PLANNING RESPONSES
SUNLIGHT HOUSE
OCTOBER 2024

GROUND FLOOR CAFE GLAZING

CDN/24/0714 & CDN/24/0713

PREVIOUS DESIGN STATEMENT

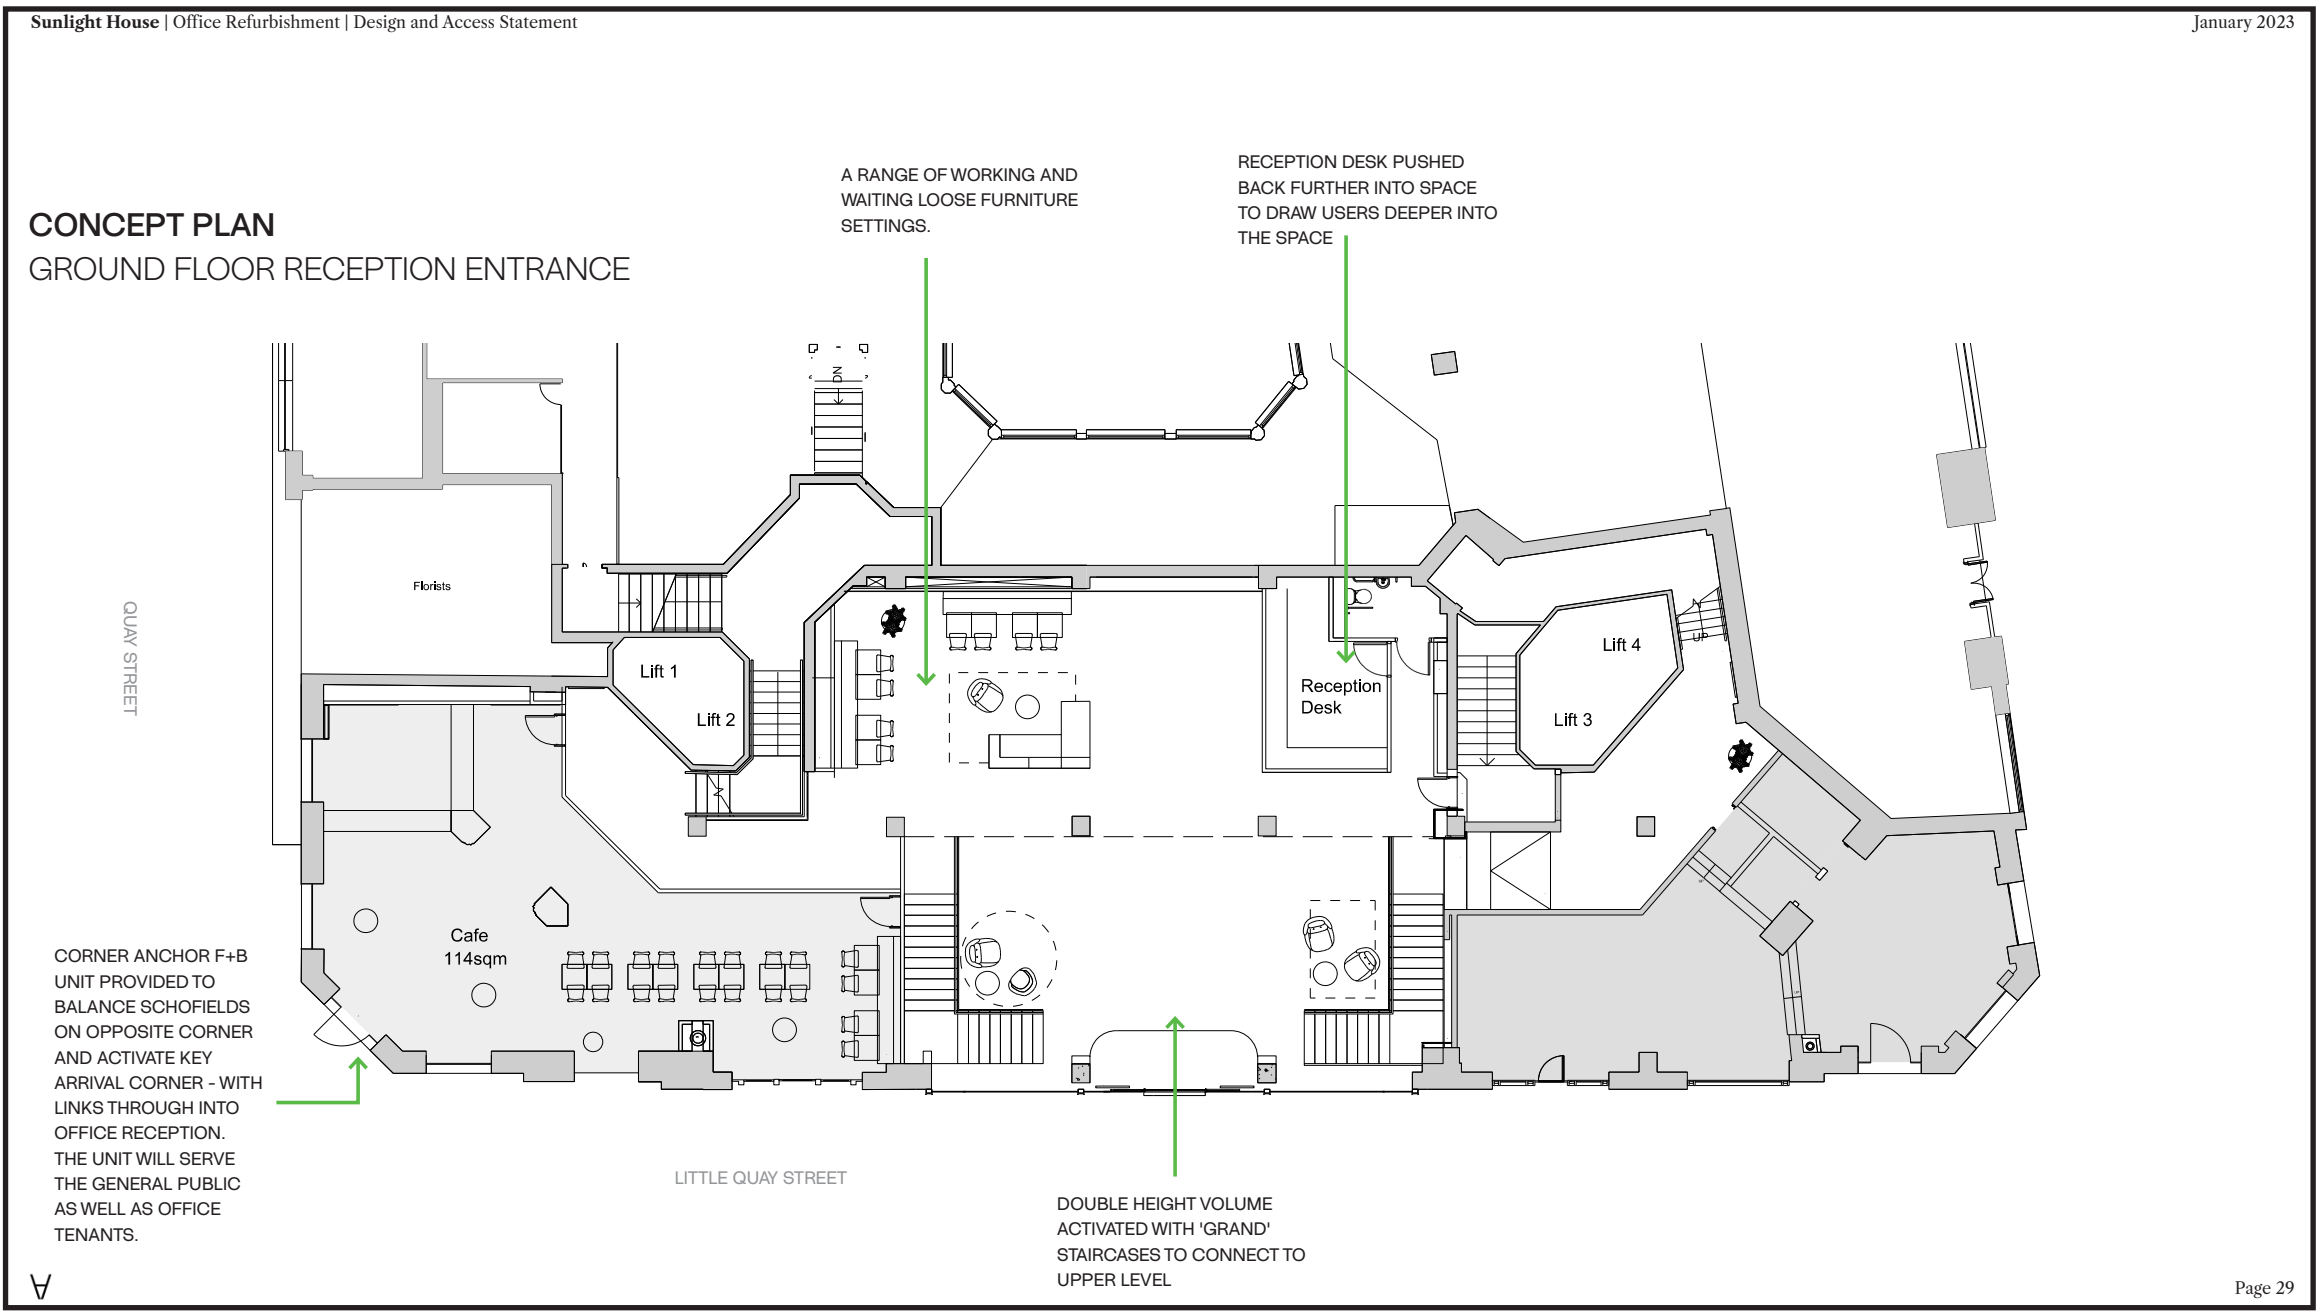
The original reception plan proposed a free-flowing corridor from the reception to the south lift lobby, separated from the cafe by a glazed partition along the full length (see CGI below).

In response to CDN/24/0714 (Condition 7) and CDN/24/0713 (Condition 11), some areas of this glazing needs to be replaced with plasterboard to support the latest reception layout and cafe testfits.

SOUTH LIFT LOBBY PARTITION STRATEGY

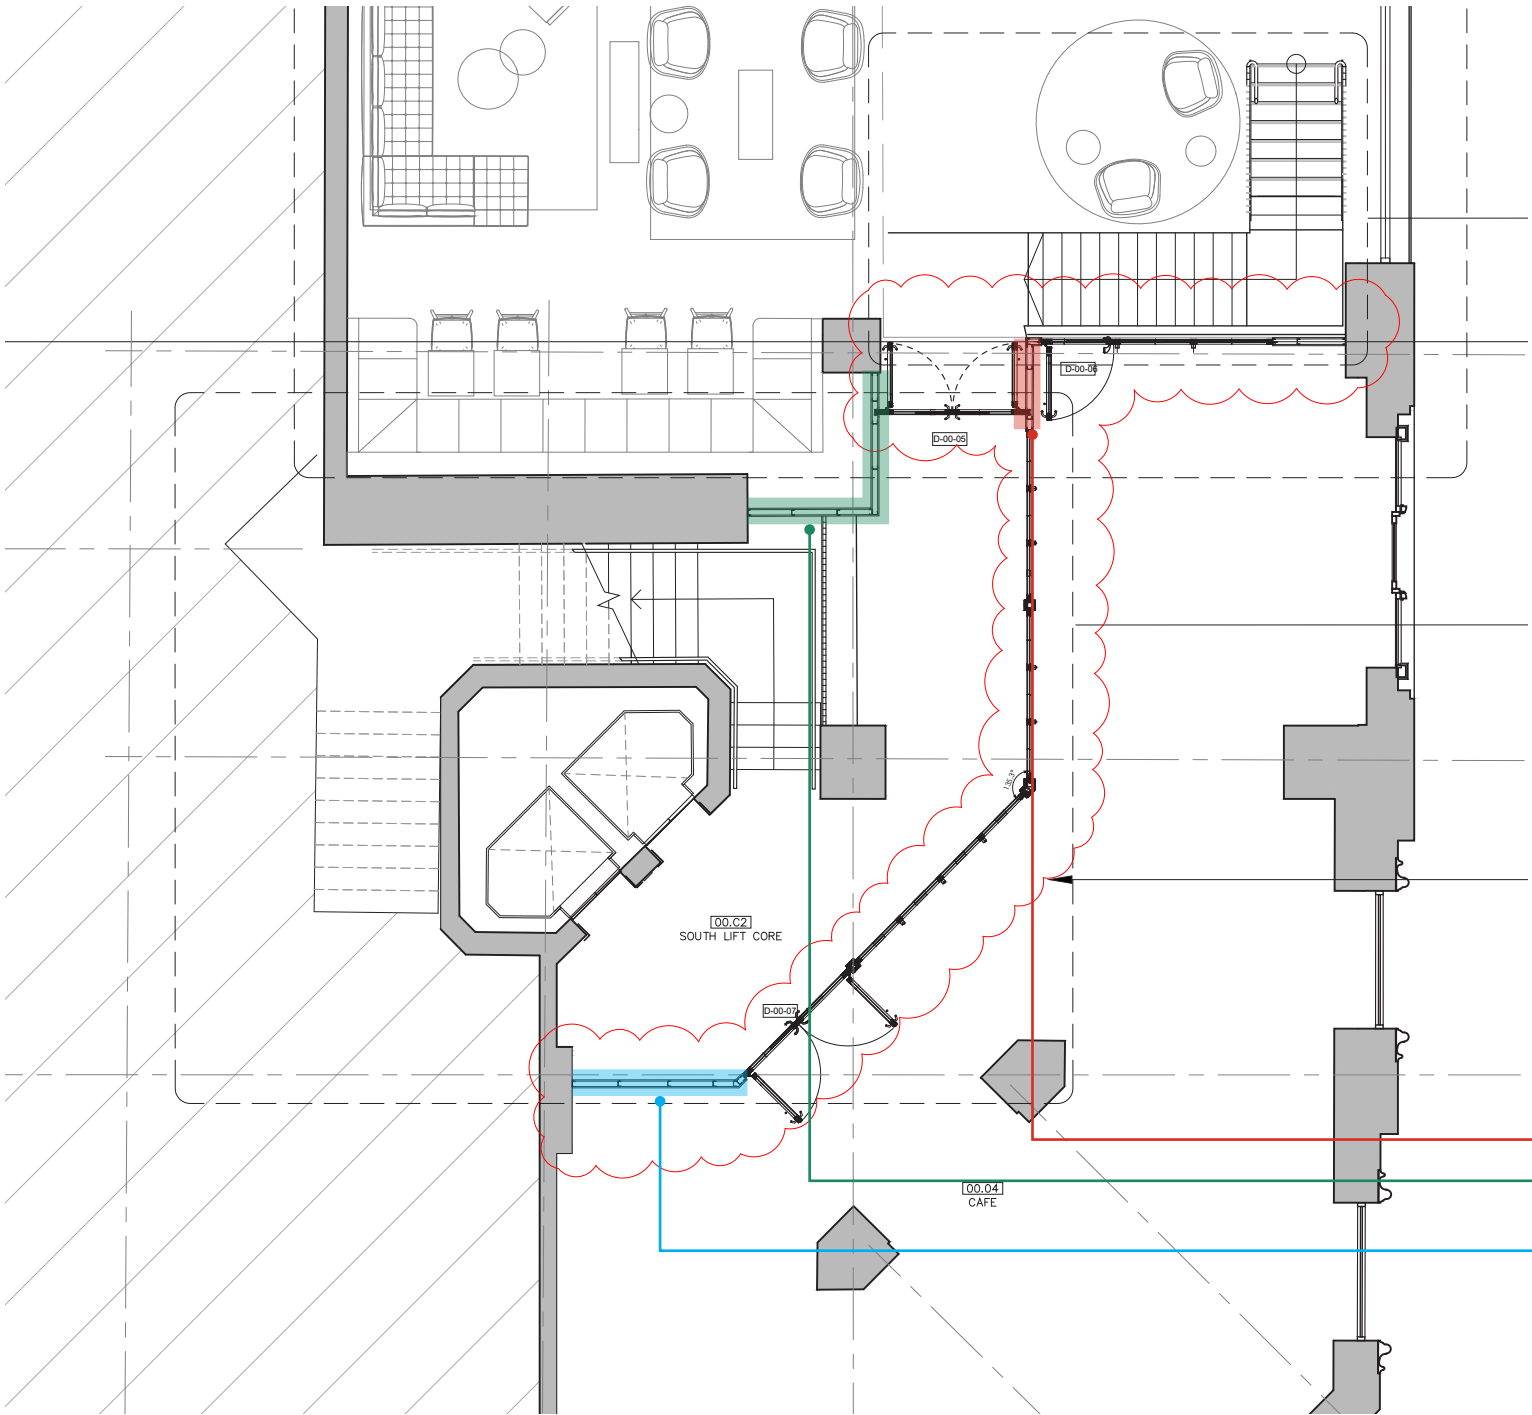
The glazing scope within the south lift lobby has been reduced and replaced with plasterboard partitions in the highlighted areas following ongoing discussions.

- Partition backs directly onto a custom joinery piece, therefore the glazing has to be modified to plasterboard to allow for a seamless joint.
- Plasterboard partition is more suitable to supporting proposed services running through this area.
- This location will likely back onto a proposed cafe storage or WC unit (see testfits for details), therefore glazing will need to be removed and replaced with plasterboard to ensure security/privacy.

PROPOSED DESIGN WITH NEW PLASTERBOARD PARTITIONS

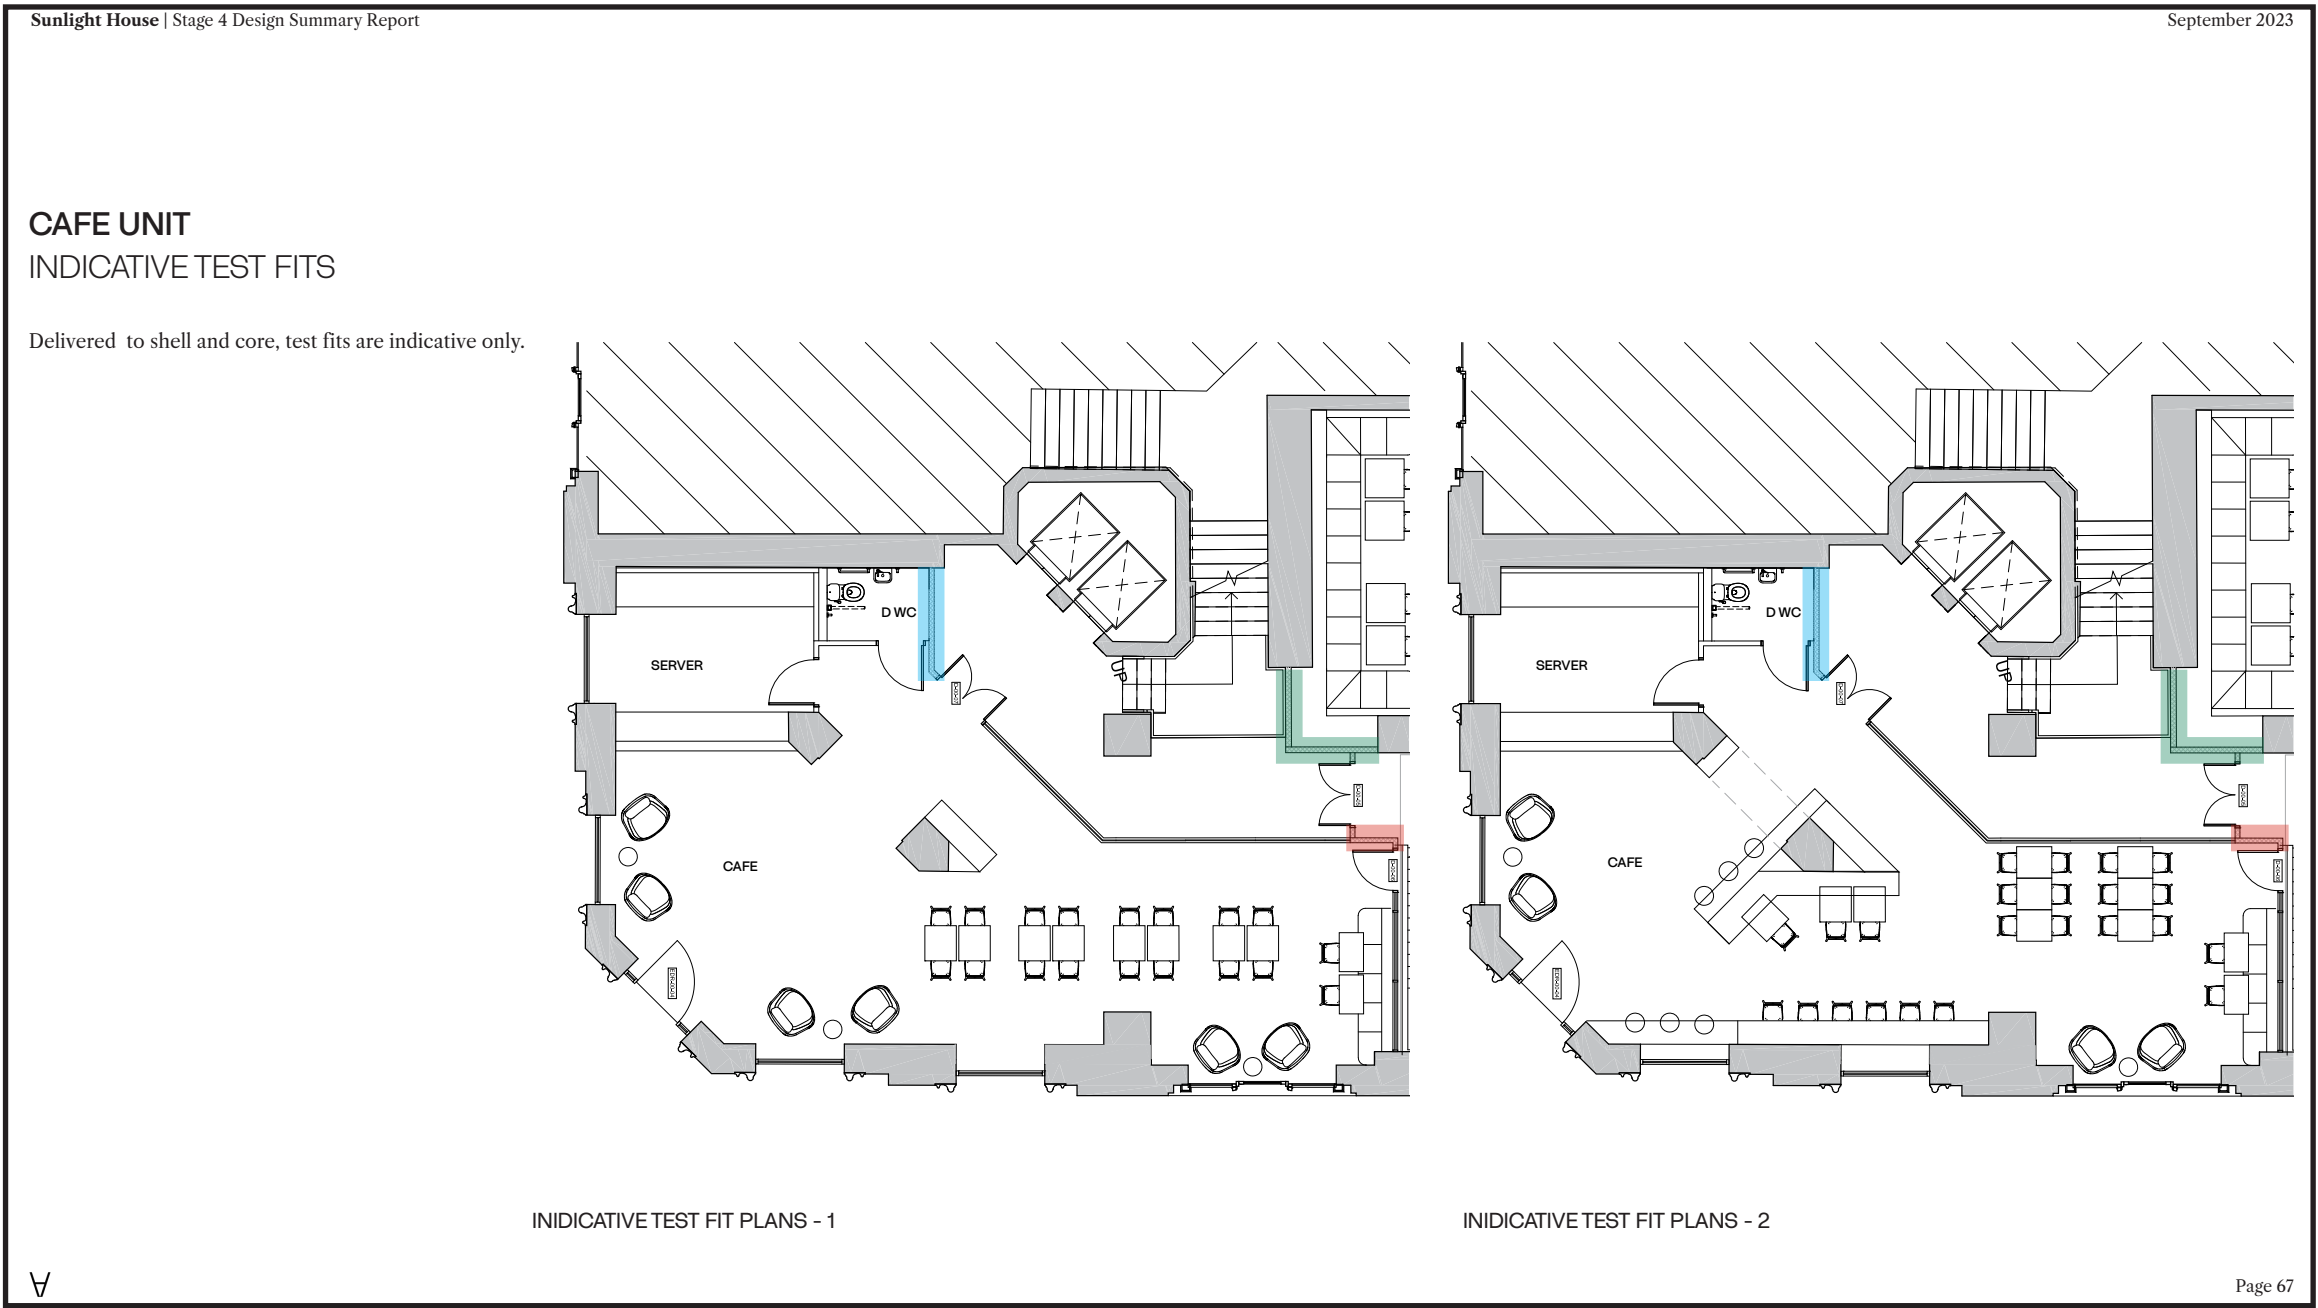
The removal of the highlighted glazing partitions will ensure that the scheme will align to the cafe testfits shown.

- Partition backs directly onto a custom joinery piece, therefore the glazing has to be modified to plasterboard to allow for a seamless joint.
- Plasterboard partition is more suitable to supporting proposed services running through this area.
- This location will likely back onto a proposed cafe storage or WC unit (see testfits for details), therefore glazing will need to be removed and replaced with plasterboard to ensure security/privacy.
